## PERMIT MODIFICATION APPROVAL

Re: Permit Modification Approval for API Number 1706287 , Well #: RANDALL UNIT 2H  
**changed lateral leg**

Antero Resources Corporation (Antero) would like to submit the following permit modifications for two approved wells on the existing Stewart Pad. We are requesting to move the horizontal laterals, to accommodate 660 foot spacing between wells, which will change the bottom hole locations of the Randall Unit 1H (API# 47-017-06286), and Randall Unit 2H (API# 47-017-06287).

Proposed Well No. Randall Unit 2H

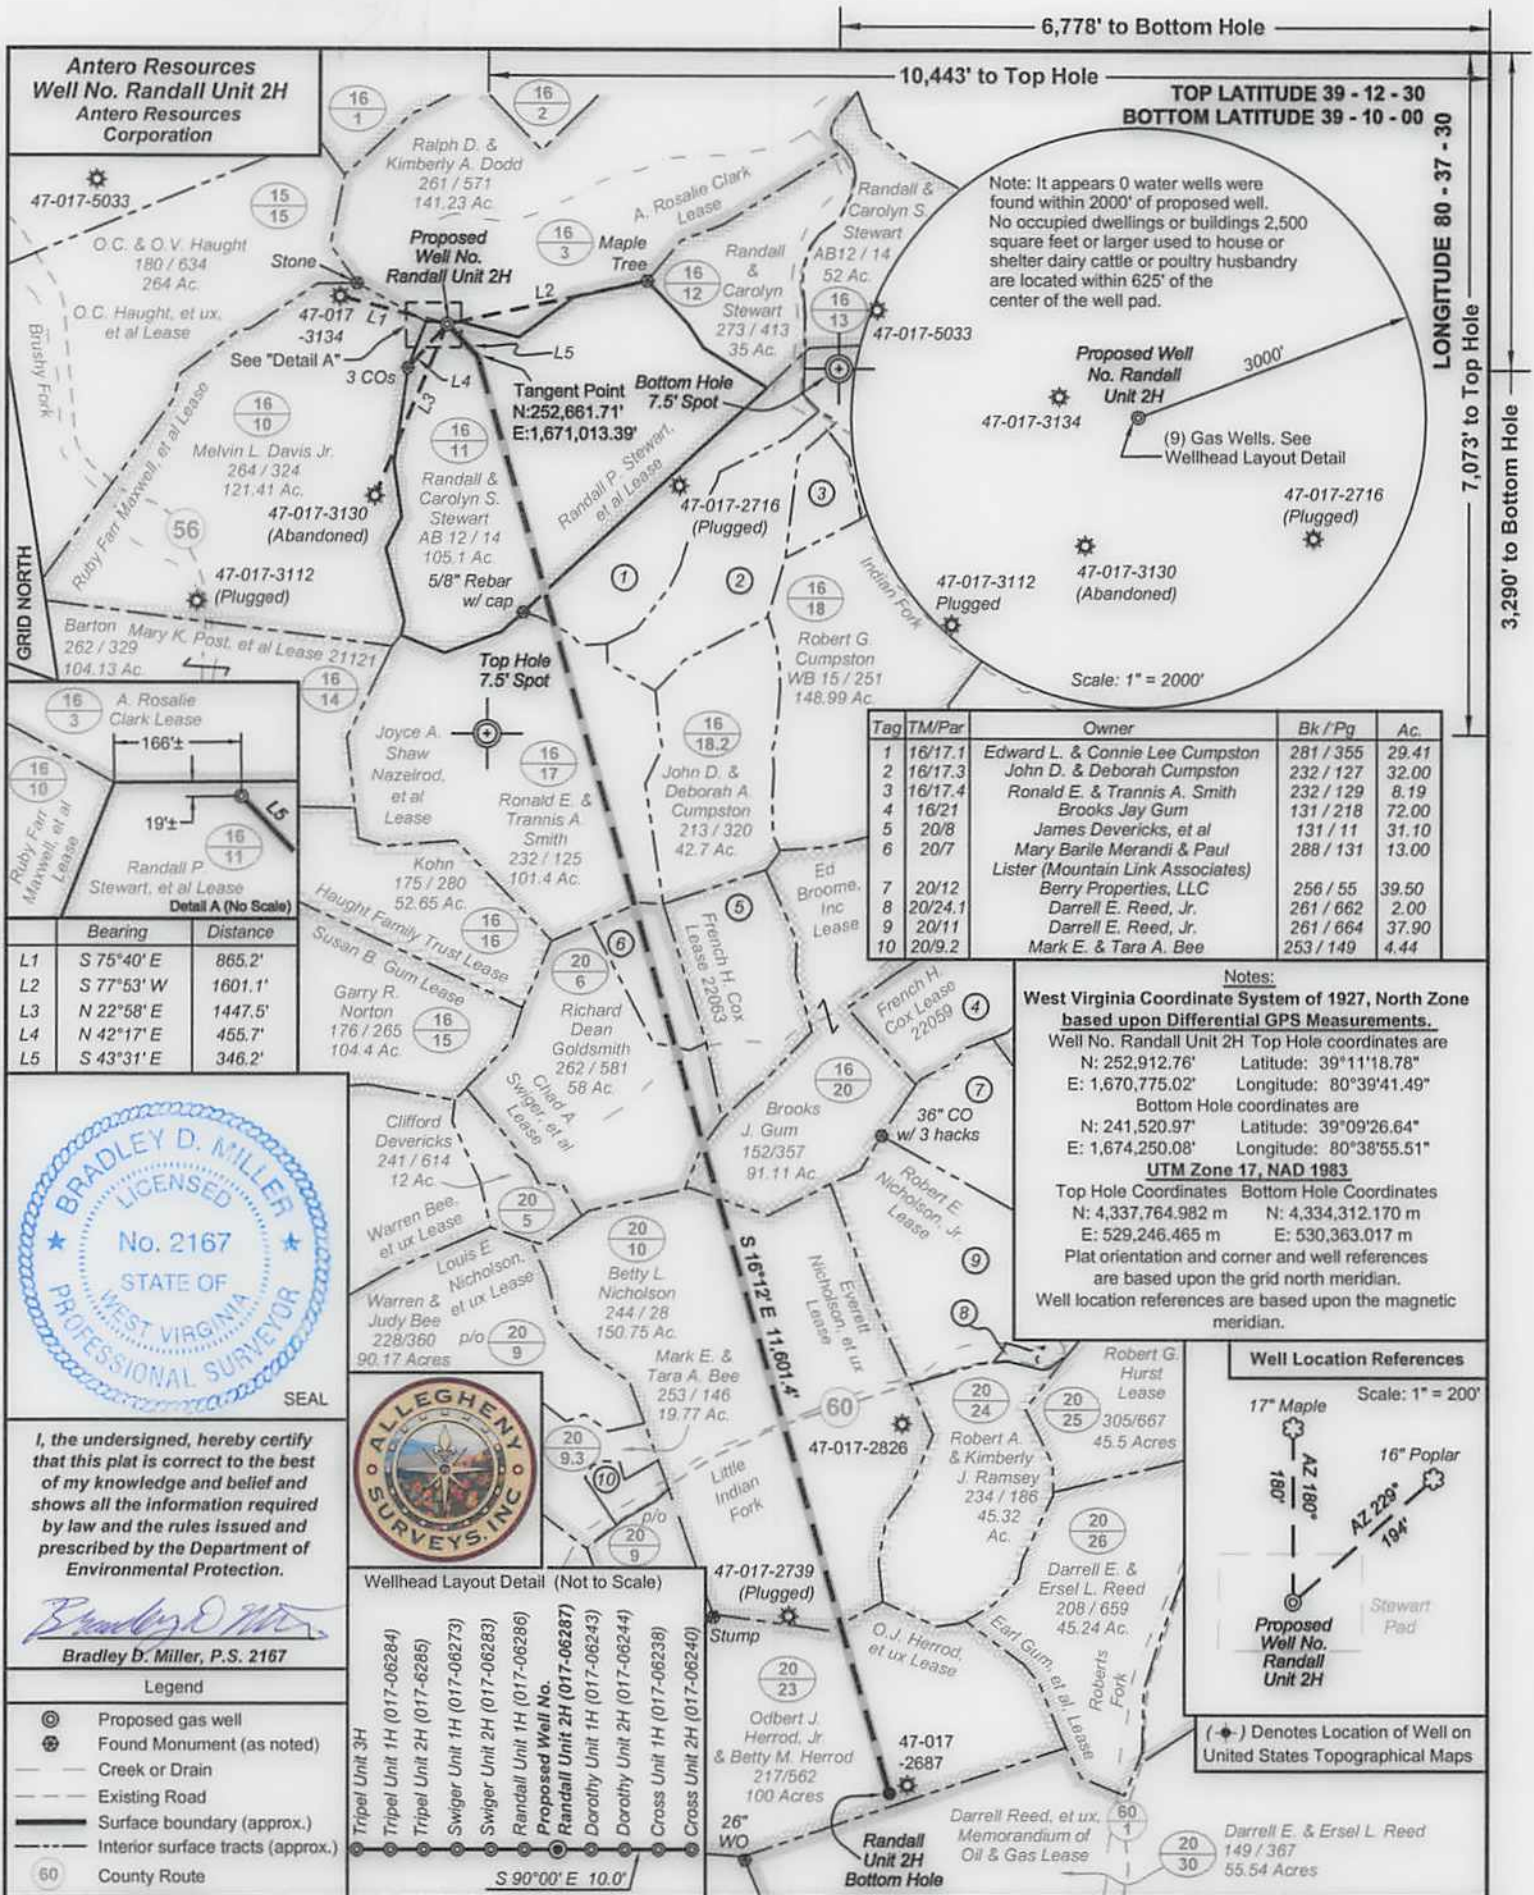
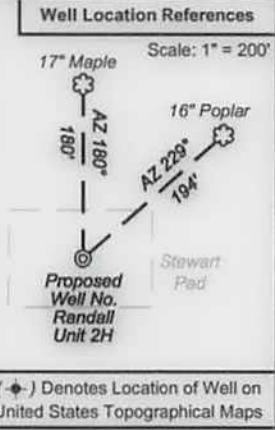
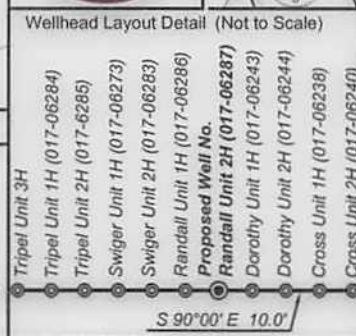
- REVISED Form WW-6B, which shows the revised MD and Production Casing/Cement program
- REVISED Form WW-6A1, which shows the leases we will be drilling into
- REVISED Mylar Plat, which shows the new bottom hole location

Well No. Randall Unit 2H Top Hole coordinates are  
N: 252,912.76' Latitude: 39°11'18.78"  
E: 1,670,775.02' Longitude: 80°39'41.49"  
Bottom Hole coordinates are  
N: 241,520.97' Latitude: 39°09'26.64"  
E: 1,674,250.08' Longitude: 80°38'55.51"
